CUYAMA BASIN GROUNDWATER SUSTAINABILITY AGENCY STANDING ADVISORY COMMITTEE

Cuyama Basin Groundwater Sustainability Agency

Groundwater Sustainability Plan Update

Figure 2.2-1 - Cuyama Basin Landmarks

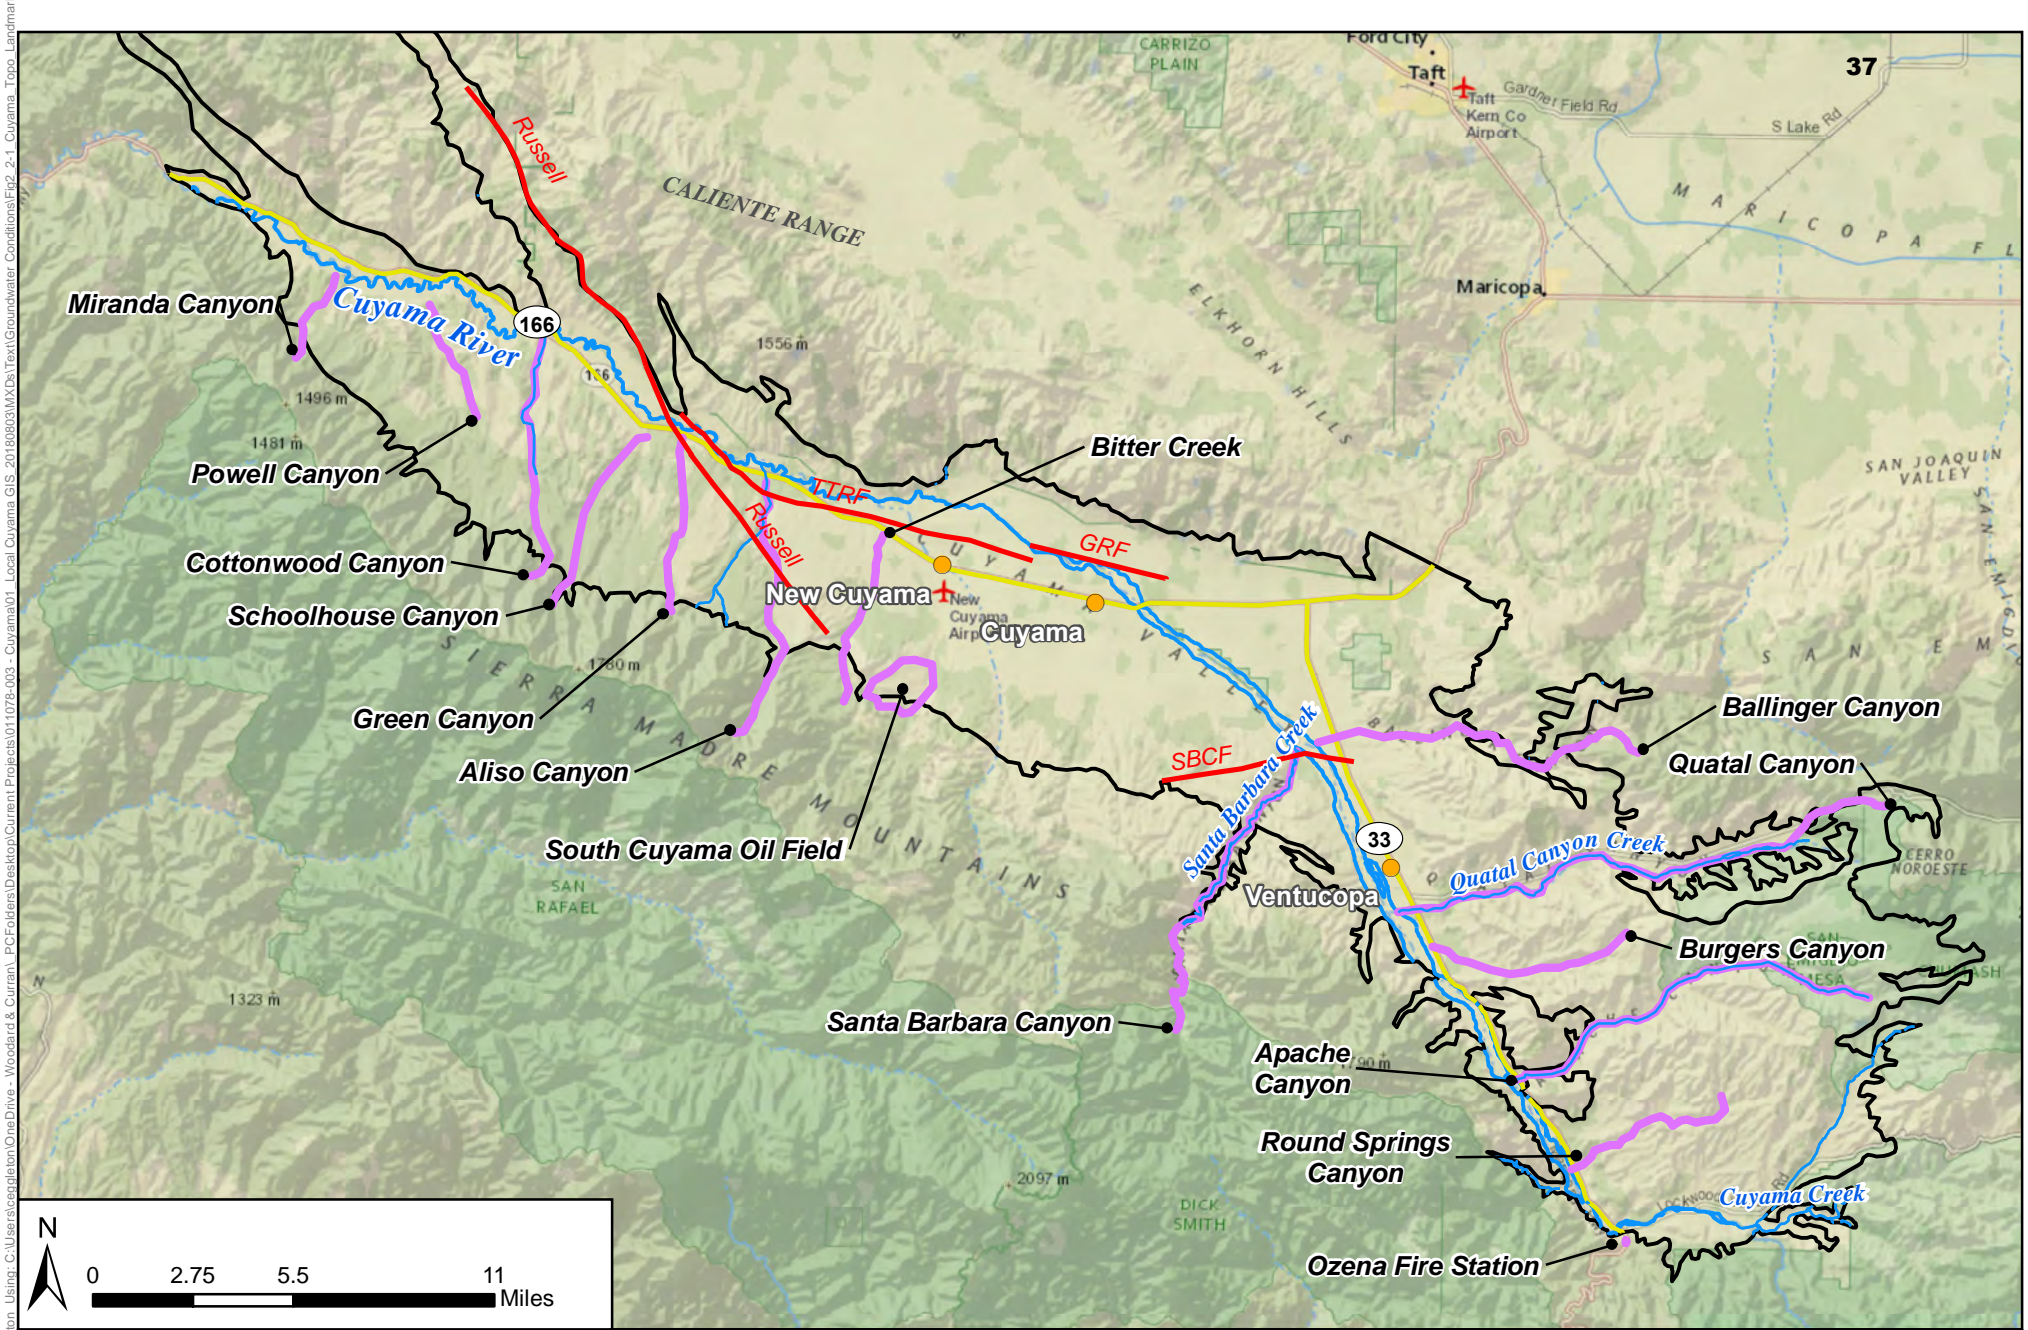
52	Jane Wooster	CBGSA Board member	Figure 2.2-1				On Figure 2.2-1 the location of the Russell Ranch Oil Field is not too accurate...it is also wrong on OPTI ID (Jane to send Brian a map).	Russell Ranch Oil Field has been removed from the figure.
53	Jane Wooster	CBGSA Board member	Appendix X				In the hydrographs (appendix X), many of the wells on our place are no longer there. It is misleading because some wells were drilled, tested once and that was it. I guess they give info about water depth.	The maps and data in Appendix X are intended to show the groundwater level information that is available historically in the Basin. Because of this, many wells that no longer exist will be included.
54	Jane Wooster	CBGSA Board member	Figures Y-4 & Y-6				Just based on what I know the stats were on our wells, it looks like Figures Y-4 and Y-6 are over-generalized. Some places we saw differences and some places the Wells didn't fluctuate all.	Comment noted. The contour maps represent estimates based on the available information in each period.

Figure 2.2-2: Cuyama GW Basin Wells with Monitoring Data Provided by DWR
 Cuyama Basin Groundwater Sustainability Agency
 Cuyama Valley Groundwater Basin Groundwater Sustainability Plan
 August 2018

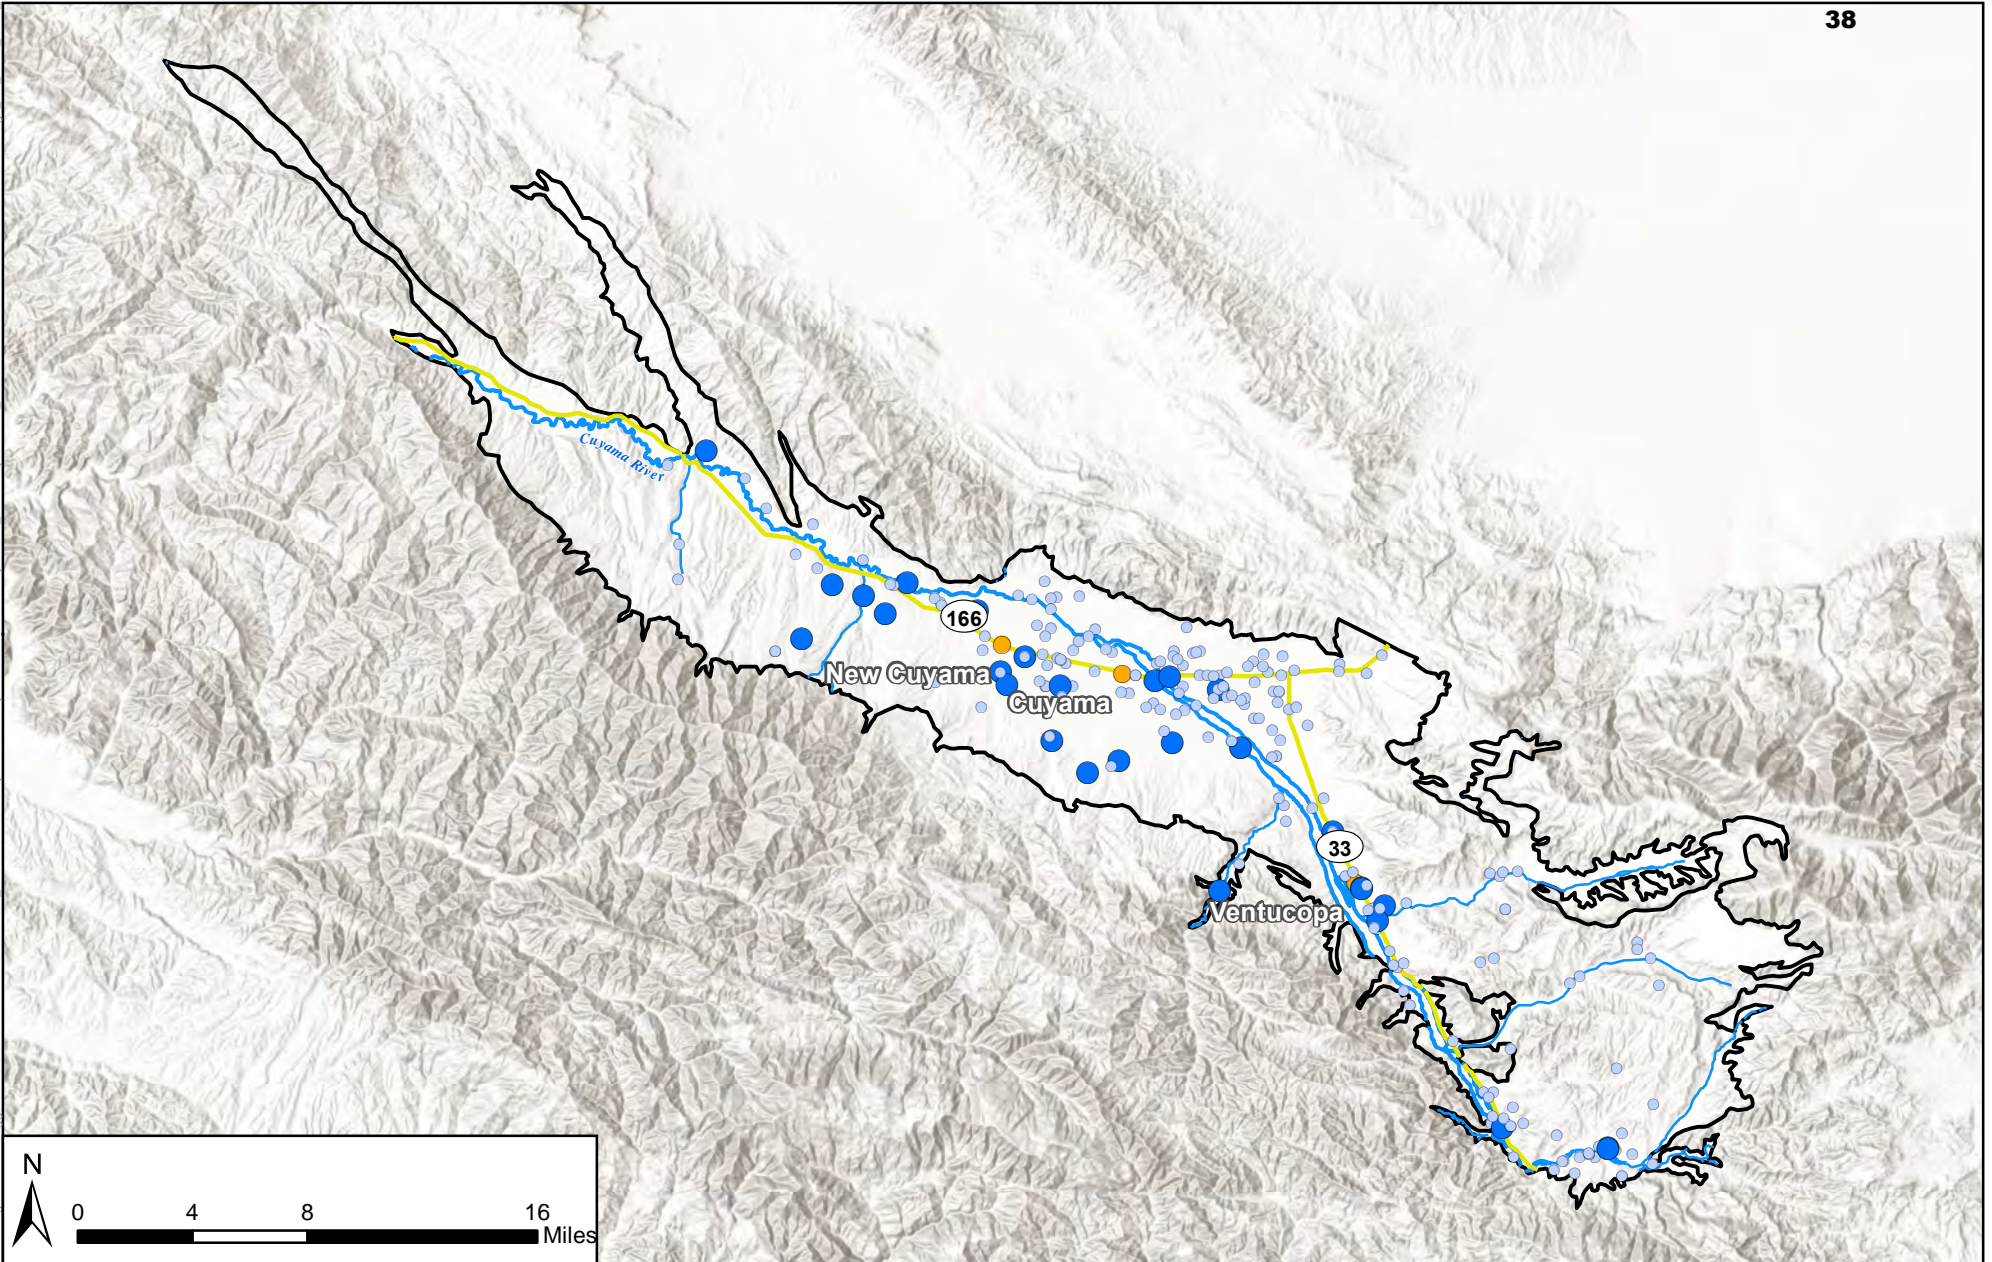
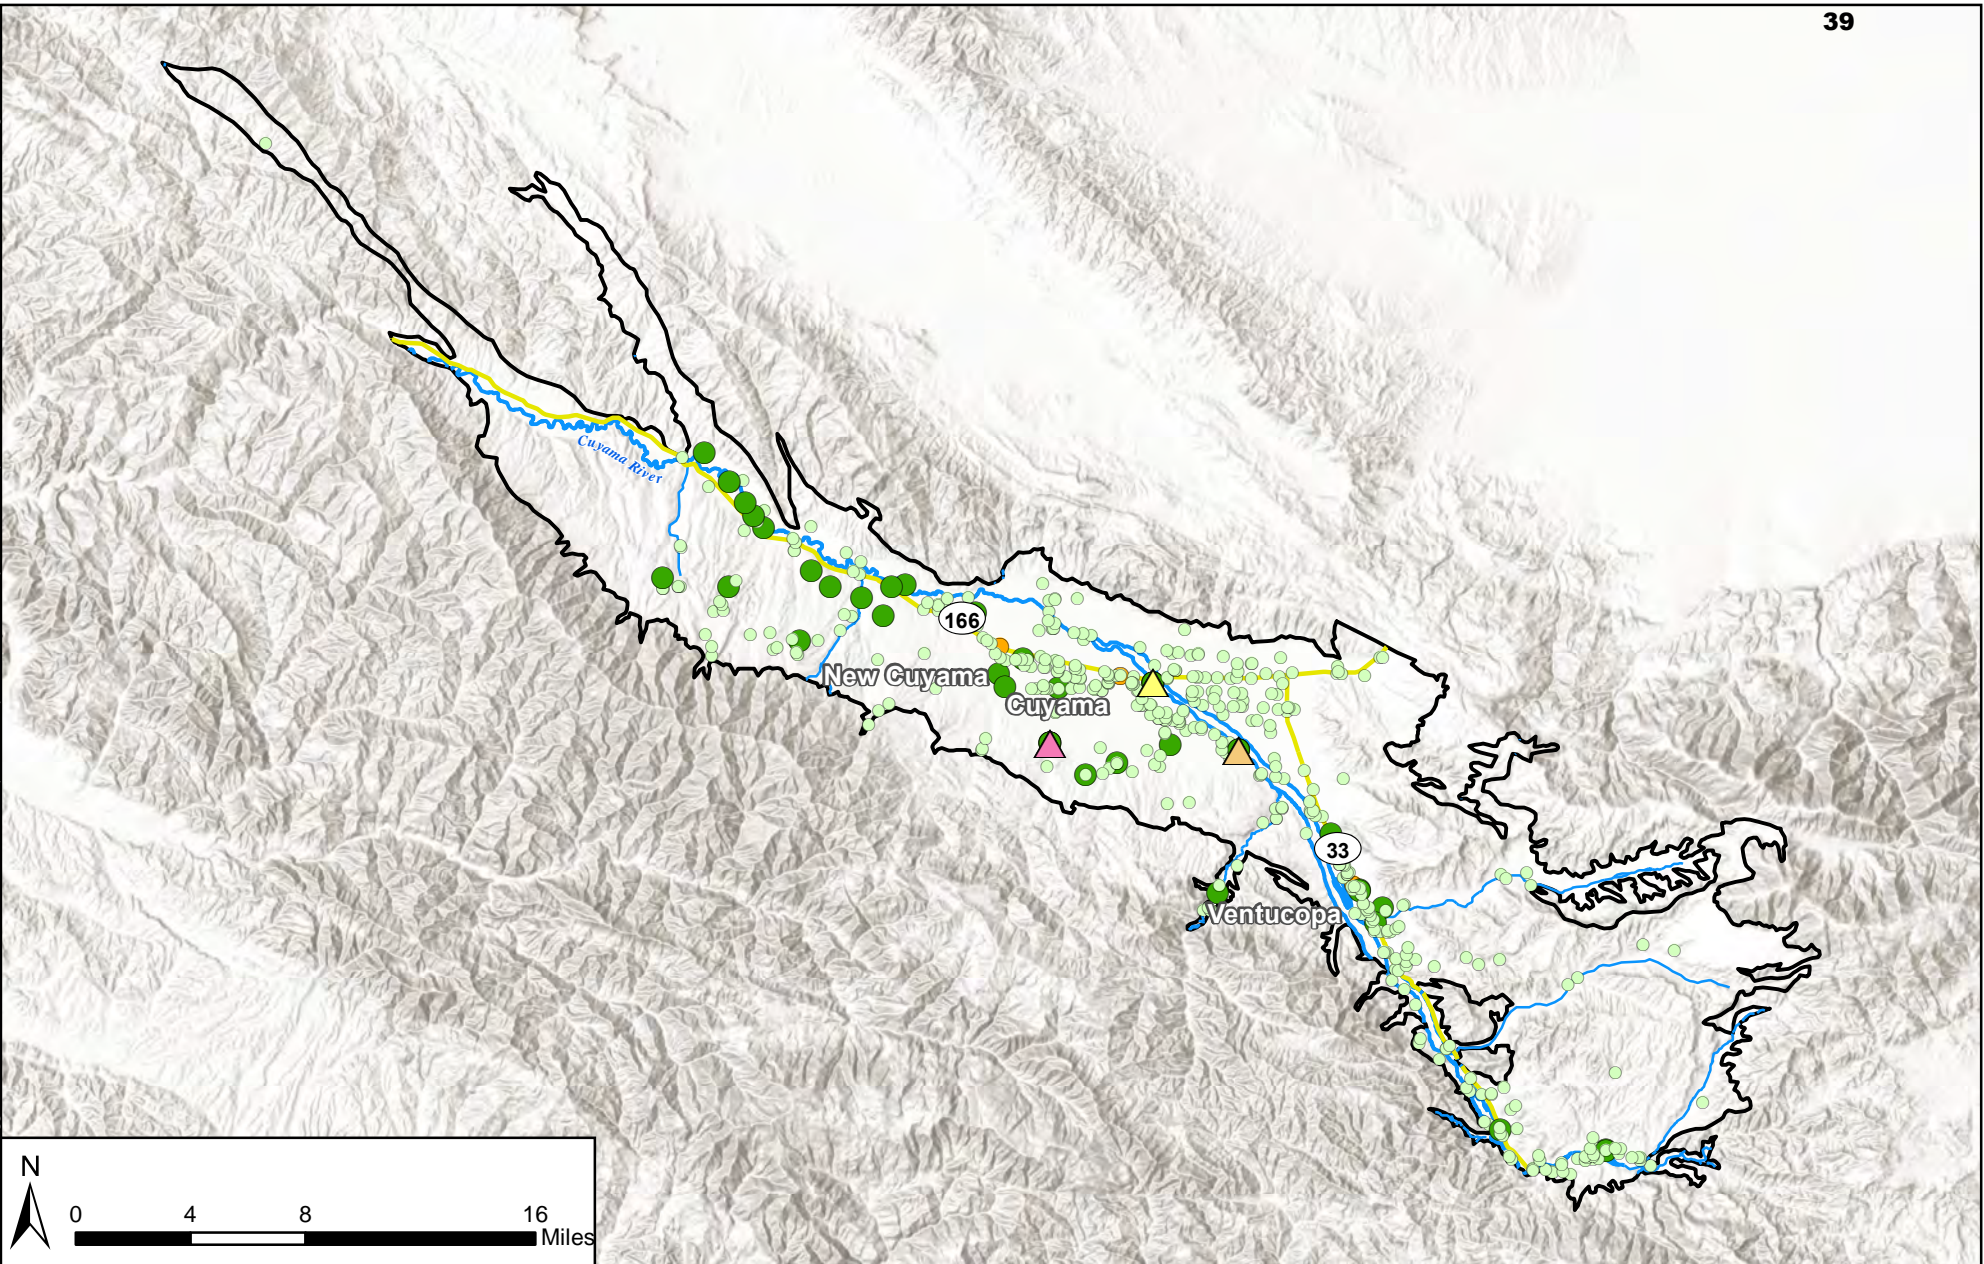
117	Matt Young, Matt Scrudato, & Fray Crease	Santa Barbara County Water Agency	Figure 2.2-2 & 2.2-3				Figures should be titled differently. These are not DWR wells. They are wells with data pulled from the DWR database. The DWR database I assume is CASGEM, which was ultimately collected by SBCWA/USGS. The database that Woodard and Curran compiled the data from is ultimately less important than how it was gathered. Need to make distinction in the title (which is different on the actual figure) of what this is supposed to show. Where they got the data and/or who collected it? Actual title on figure says "DWR Wells" which is not an accurate statement.	Figure titles have been revised for clarity.
118	Matt Young, Matt Scrudato, & Fray Crease	Santa Barbara County Water Agency	2.2.2 GW Elevation Data Processing			Roughly half of the wells from DWR's database	Please provide context for why this is important in the text. "measured in 17-18 is mentioned throughout without context. This is a plan that will be issued in 2020. Why 17-18 is the focus needs to be explained.	Text has been revised for clarity.

Figure 2.2-5: Cuyama GW Basin Wells with Monitoring Data Provided by Private Landowners

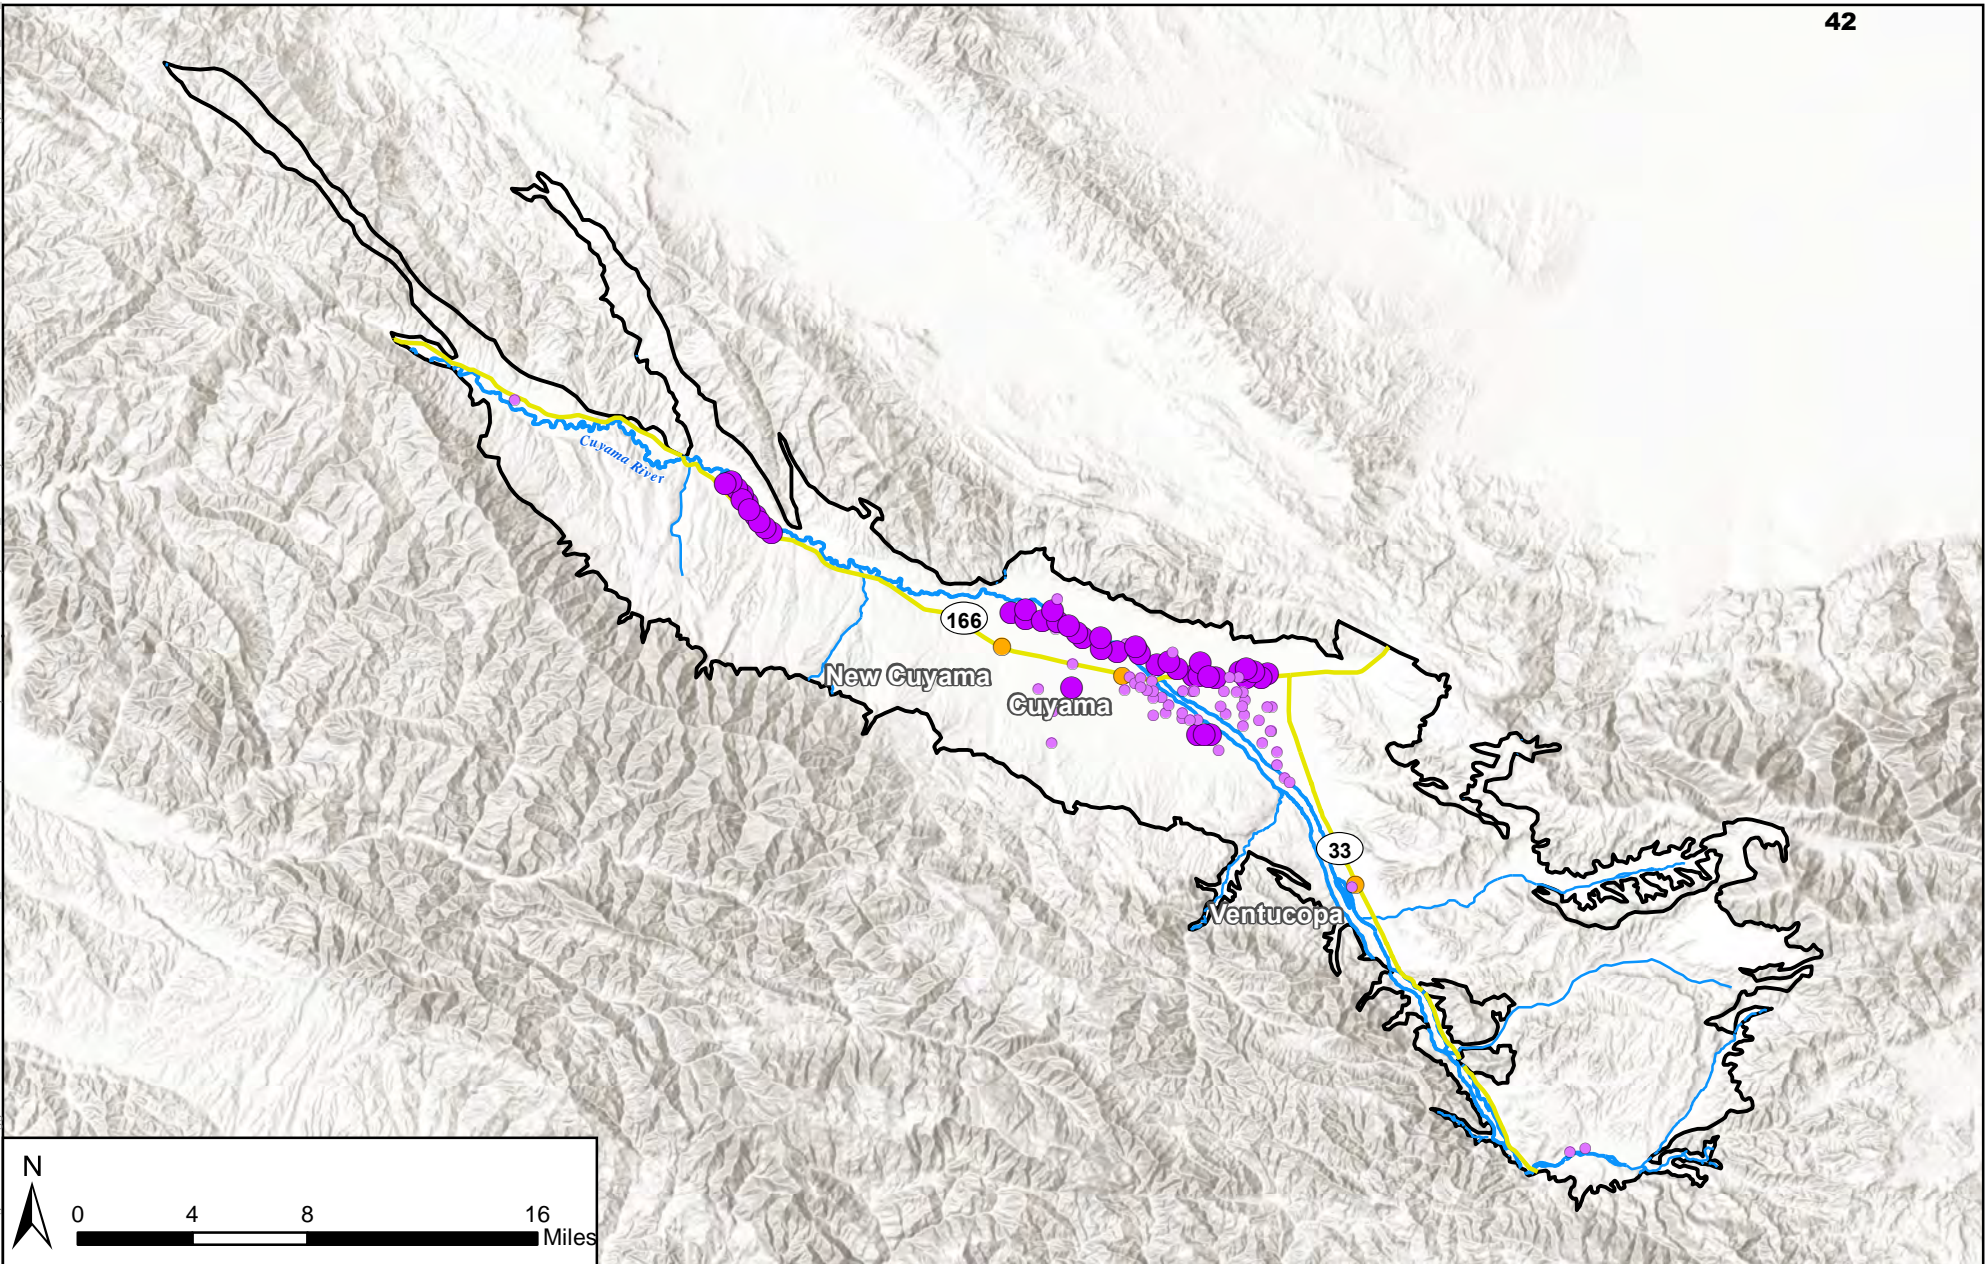
126	Matt Young, Matt Scrudato, & Fray Crease	Santa Barbara County Water Agency	2.2.2 GW Elevation Data Processing				Need to add a section somewhere that describes QA/QC process, who does it (USGS, SBCWA), who doesn't (Bolthouse/Grimmway/Grapevine), and why.	This has been addressed in a footnote.
127	Matt Young, Matt Scrudato, & Fray Crease	Santa Barbara County Water Agency	2.2.2 GW Elevation Data Processing			The locations of SBCWA well data are located	What is the difference between these wells and the wells referenced in Figure 2.2-4? SBCWA should be taken off Figure 2.2-5 for several reasons (we don't own the wells shown, we're not a private company, we're not ag, etc). All of wells measured by Matt Scrudato should be in Figure 2,2-4	Wells included in these figures have been reviewed and it has been confirmed that the Figure 2.2-4 includes all well data provided by the SBCWA and that Figure 2.2-5 includes all well data provided by private landowners.
